TO: Ragged Mountain Recreation Area Foundation Board of Directors  
FROM: Jeff Kuller  
DATE: 4/9/10  
SUBJECT: Recommendation to Purchase Used Triple Chairlift

Subject: Riblet Triple Chairlift  
Camden Snow Bowl

**PRELIMINARY LIFT ENGINEERING DATA**

**CAMDEN SNOW BOWL  
RIBLET TRIPLE CHAIRLIFT**

Riblet Drive Terminal and Tower #1

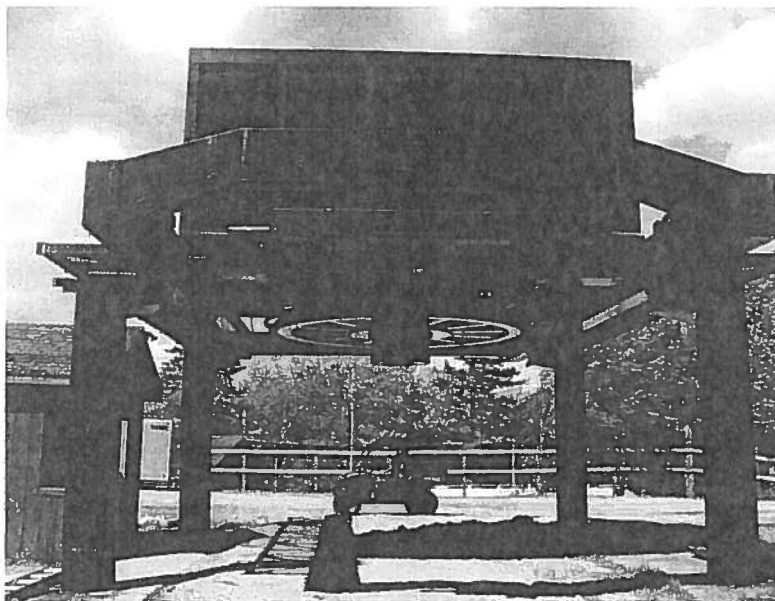
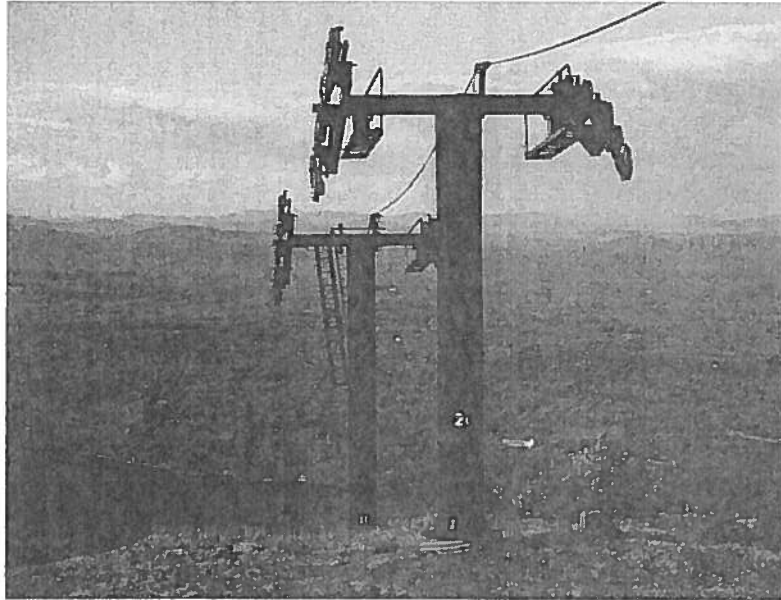
- **Necessary** - The drive terminal is a 4 legged, combined overhead drive-tension terminal with hydraulic tensioning. The 4 steel support legs are embedded in the existing concrete footings; thus, when the drive terminal is dismantled the legs will need to be cut-off above the footings. A new length of steel tube (about 5') will need to be added to each leg when the lift is reinstalled.
- **Required** – A bullwheel retention device must be installed.
- **Recommended** - The Sabina electric drive is somewhat antiquated. It will need a device that can monitor the lift deceleration rate. It is recommended that this electric drive be replaced with a new and up to date electric drive.
- **Recommended** - The existing electric motor is a 300 Hp motor. Although this motor could be used at Camden Snow Bowl our preliminary engineering calculations indicate that a 250 Hp electric motor will

- **Necessary** - The haul rope must be replaced as it has reached the end of its useful service life.
- **Necessary** – A new communications cable, connecting hardware and terminal boots will need to be installed.

- **Necessary** - According to our preliminary profile calculations for the Relocated Riblet chairlift at Shawnee Peak approximately 17 towers will be required. Bill Fitzcharles and I verified that there are 10 CTEC towers in storage at Shawnee Peak and we took measurements on these towers. Towers #1 and #7 on the existing Riblet chairlift are still standing on the lift line and these 2 towers will be available to Camden Snow Bowl also. New base flanges for these 2 towers will be required as the existing Riblet base flanges are embedded in the existing concrete tower footings. There are 5 remaining tower bases as a result of Shawnee Peak using portions of steel tower tube for the relocation of their CTEC chairlift. In summary, there are 12 towers and 5 tower bases available. This is enough for the Camden Snow Bowl installation according to our preliminary profile engineering calculations. Additional 20" dia. x 1/4" wall steel tube will be needed to make-up the tower masts for the 5 existing tower bases.

- **Necessary** - All sheave assemblies from the existing Riblet chairlift are available and will be used at Camden Snow Bowl. At Camden Snow Bowl the entire Riblet tower top (including sheave assemblies) from each Riblet chairlift tower will be used and installed on the CTEC tower masts. Stevens Engineering will design a steel flange connection for the Riblet tower tops and CTEC tower masts so that the tower tops can be bolted to the tower masts. As mentioned previously, 2 of the towers will consist entirely of Riblet original equipment.

- **Recommendation** - The existing Riblet tower tops presently do not have lifting frames. Although not a requirement of the ANSI B 77.1-2006 Standard, lifting frames are extremely beneficial in the performance of routine and preventive maintenance on ski lift towers. Camden Snow Bowl should consider the possibility of adding lifting frames to all support towers or, at a minimum, obtaining or fabricating a portable lifting device that could be used on all support towers.

- **Required** - The return terminal will need a bullwheel retention device.
